Attachment E

Submissions

Subject: D/2024/524 117 Victoria St Potts Point

Image 1

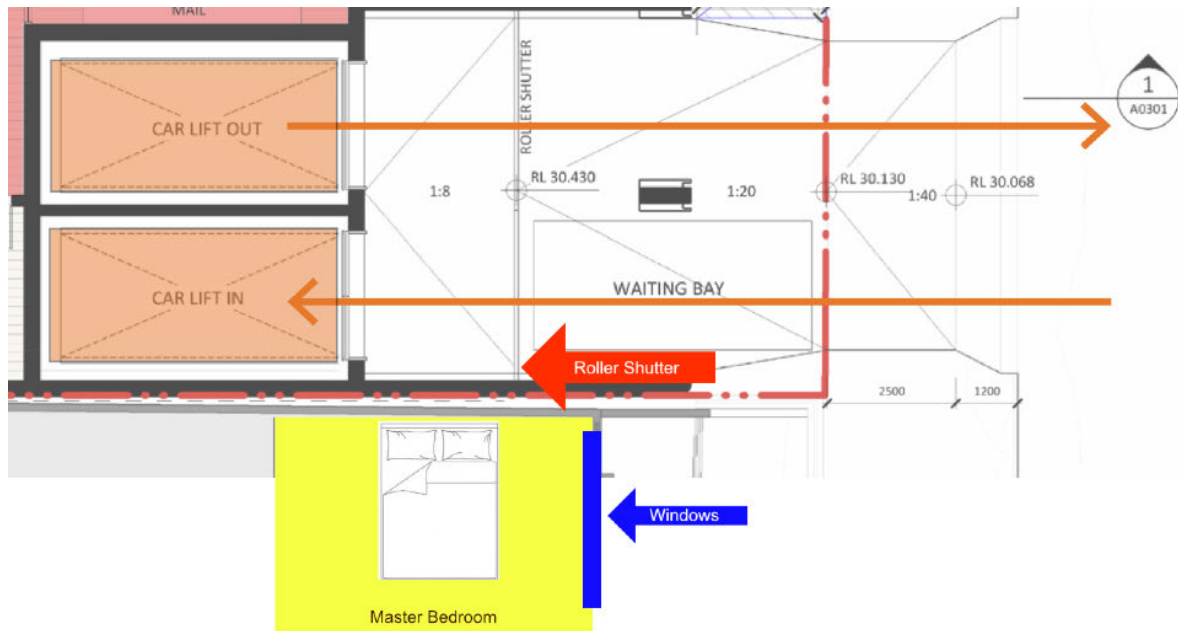
With reference to the frontage on Victoria Street, as depicted by their supplied photo and drawing:

Image 4

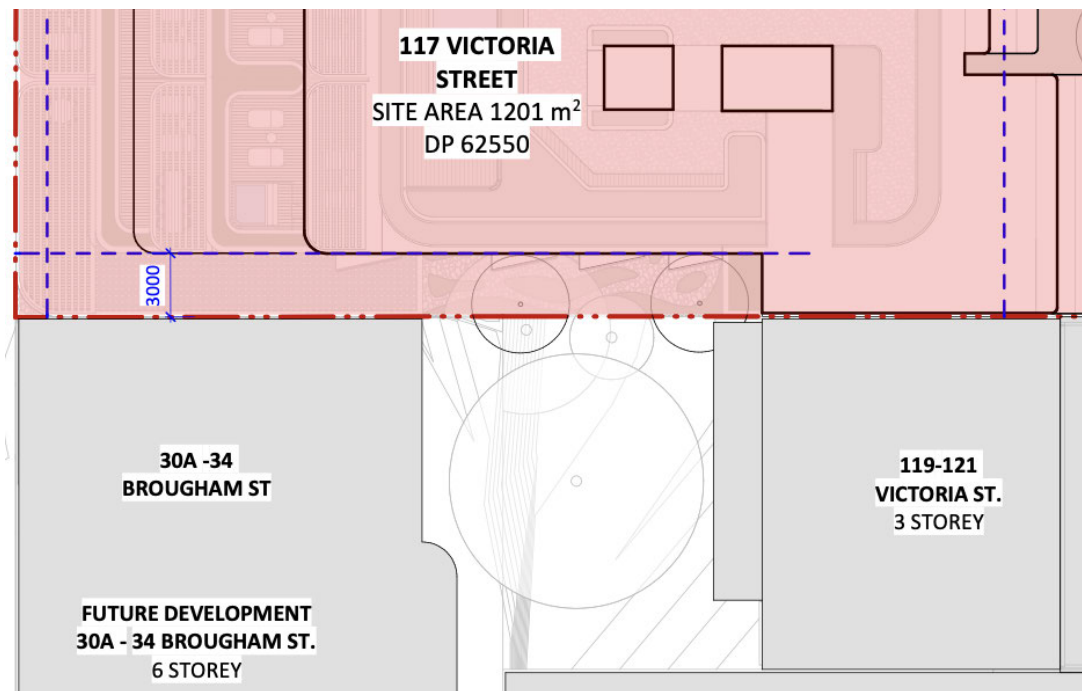
- The communal rooftop open space and reduced proximity to our building will cause excessive noise. Together with the approved development on Brougham Street as mentioned above, the rear of our block will be completely closed in (see image 4 below). With the reduced proximity of the new development to our block, noise from the communal rooftop and pool will therefore be exacerbated particularly as this area will attract groups of people and parties, causing excessive noise into the main living areas of the apartments in our block.

The building should therefore not be permitted to be built so close to our existing building and there should not be a communal rooftop space and swimming pool permitted.

Image 5

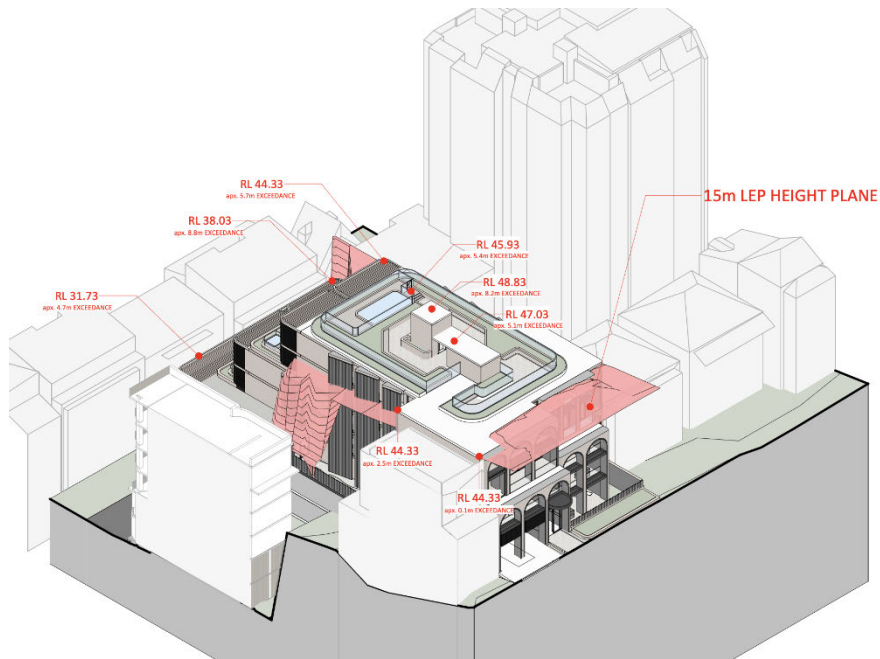
- The proposed development exceeds the legal height limit – The height restrictions exist for a reason and should be enforced. No part of the building should exceed the permissible height limit by any amount (see image 5 below).

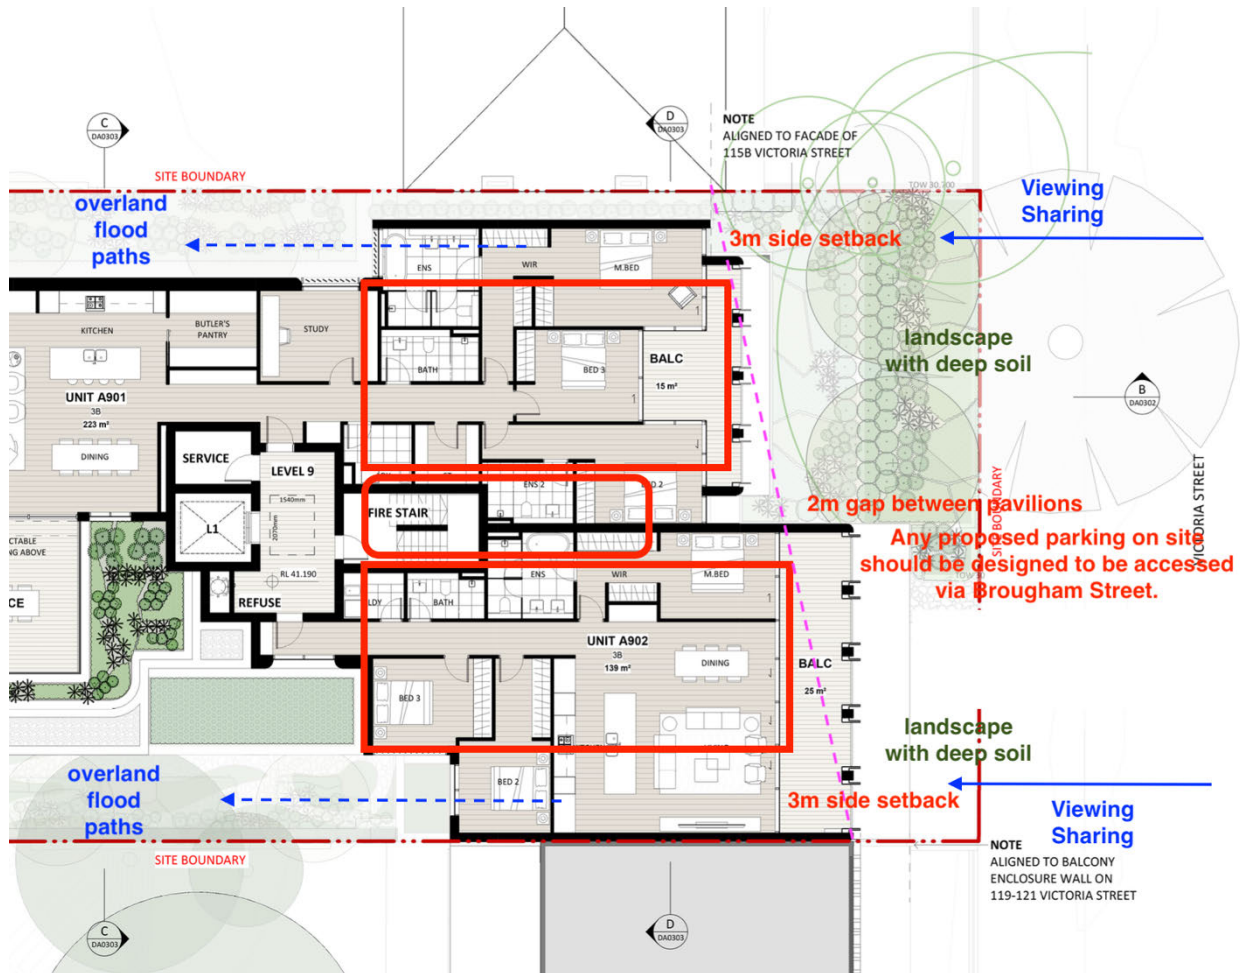
Section D of this submission titled '*Request for amended plans to be submitted to better address impacts upon adjoining properties*', addresses the amendments that my clients seek to better resolve their amenity issues.

My clients ask for the following amendments:

- Reduce the built form facing Victoria Street:
 - Side Setbacks 3m
 - Front Setback: align with neighbouring setbacks
 - Two Pavilions: with centre recess
 - Height: Level 06 to be lowered to match levels of Victoria Street, with four levels above at 3.15m storey heights.

- Any proposed parking on site should be designed to be accessed via Brougham Street.
- No excavation in the front setback zone, to allow for a continuous deep soil zone along Victoria St for deep soil planting and to better protect Tree 1
- Unacceptable Adverse Acoustic Privacy Impacts from the incomplete consideration of the roof top terrace: RBL + 5dBA as proposed by the Applicant is considered unacceptable. This should be reduced to RBL + 2dBA, with access restricted to daylight hours only
- Unacceptable Adverse Acoustic Privacy Impacts from the incomplete consideration of the operation of the car lifts, mechanical roller shutter, and

D. REQUEST FOR AMENDED PLANS TO BE SUBMITTED TO BETTER ADDRESS IMPACTS UPON ADJOINING PROPERTIES

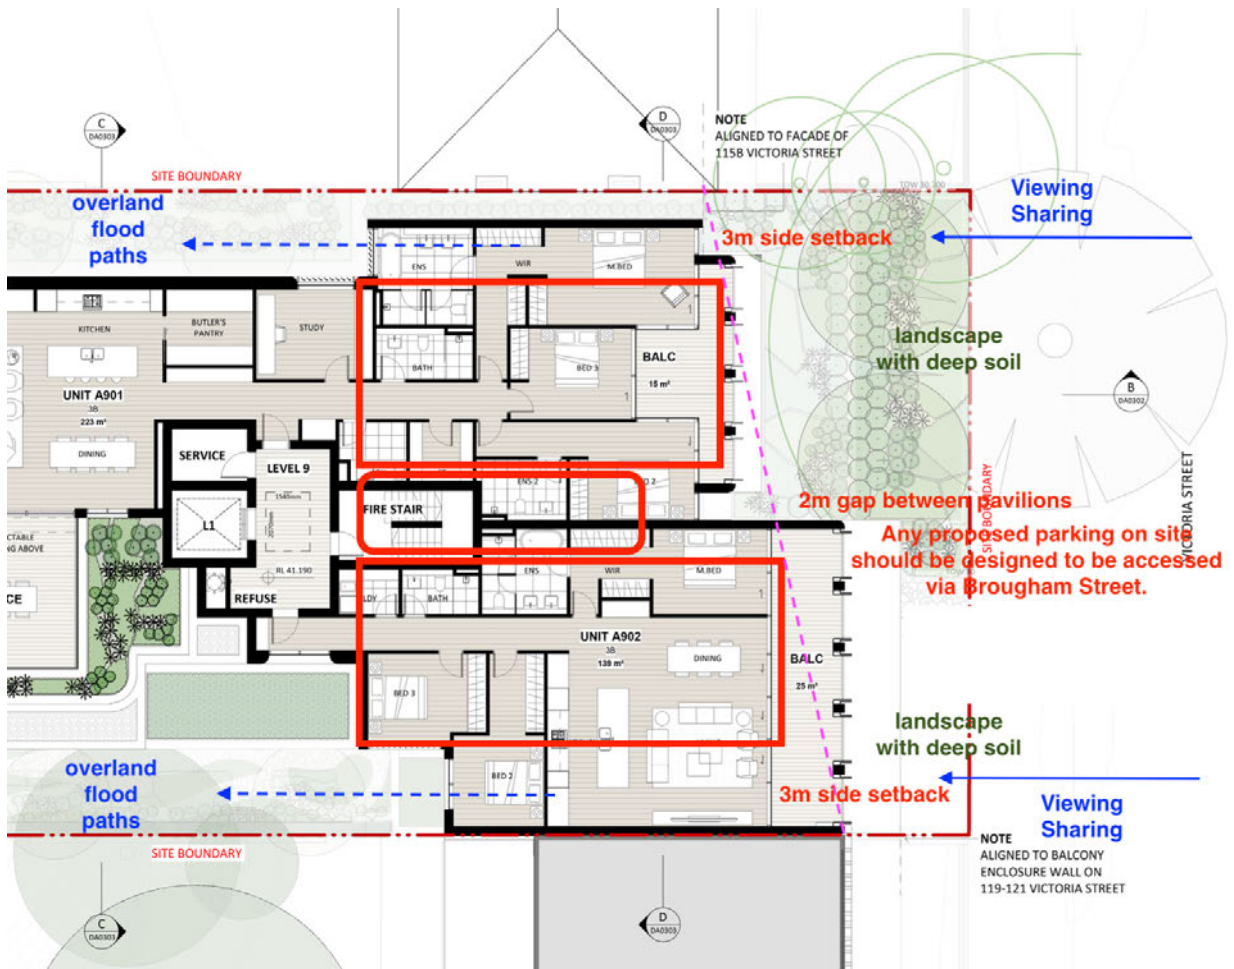
A compliant building design would reduce the amenity impacts identified.

Prepare and submit further supporting information and amendments to the assessing officer directly addressing the issues.

Figure 18 Height blanket diagrams of existing building

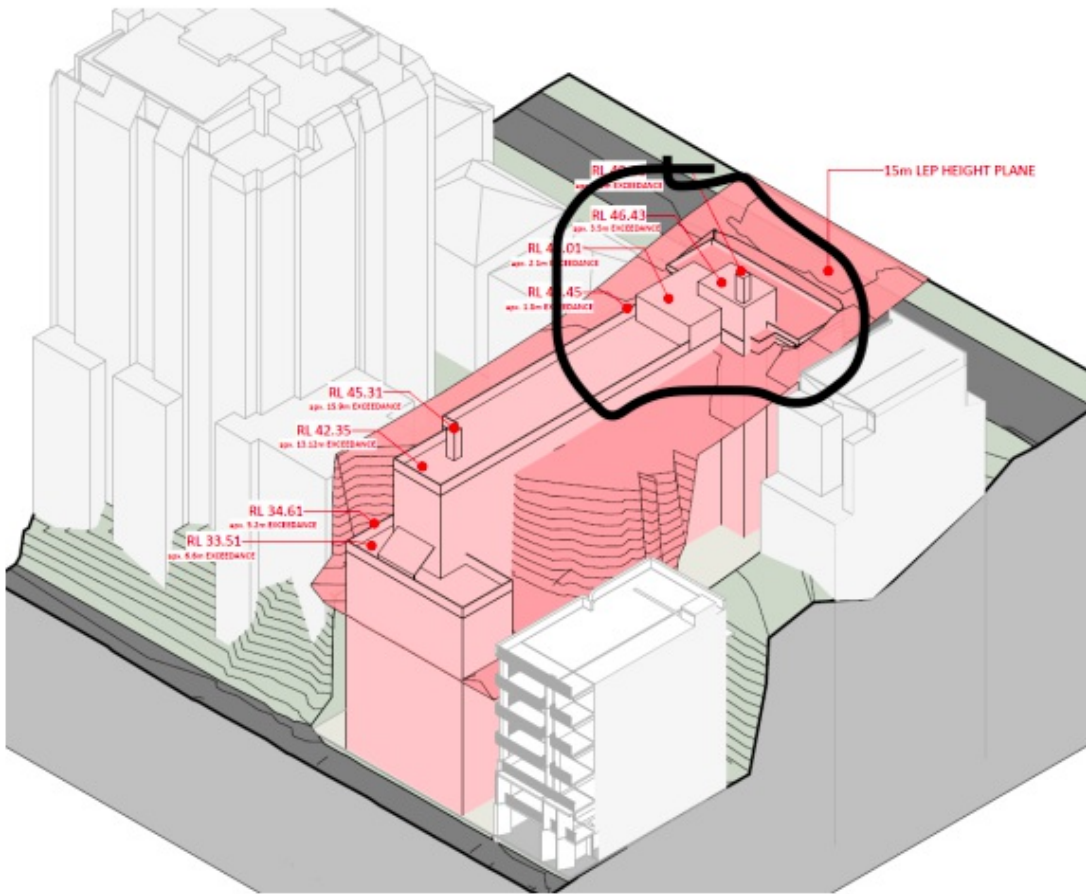
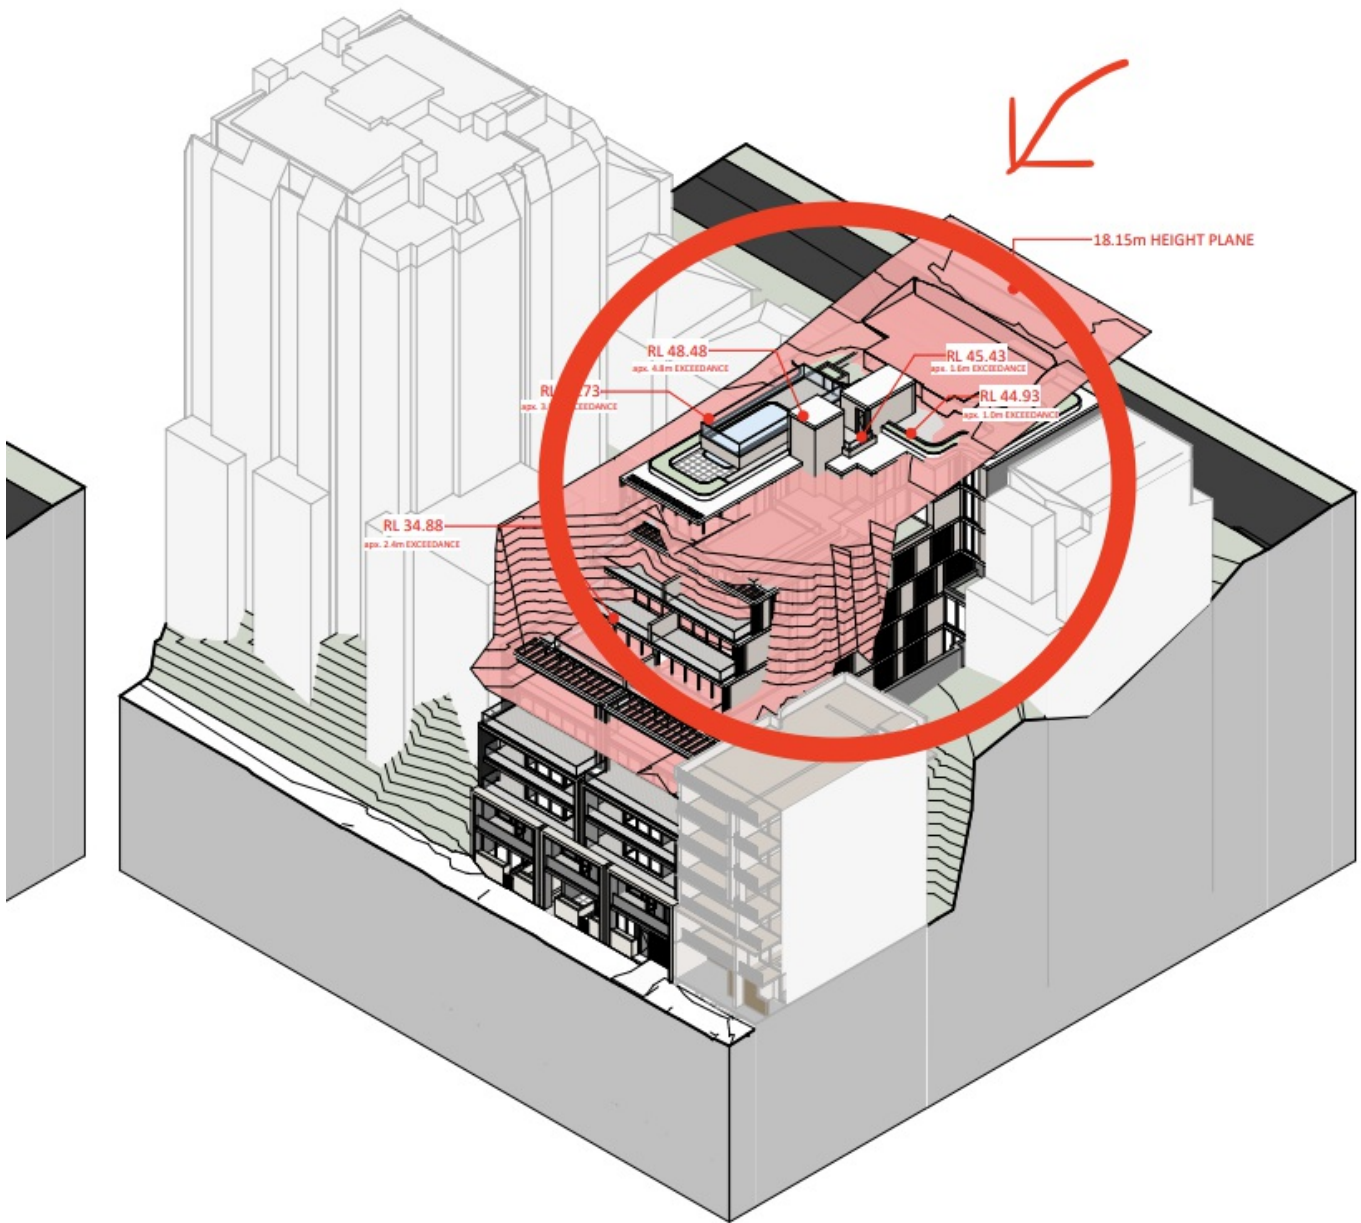
Current - circled breach in black

Proposed - circled my objection to increasing non-compliant height and volume of non-complaint height to block views in Red below
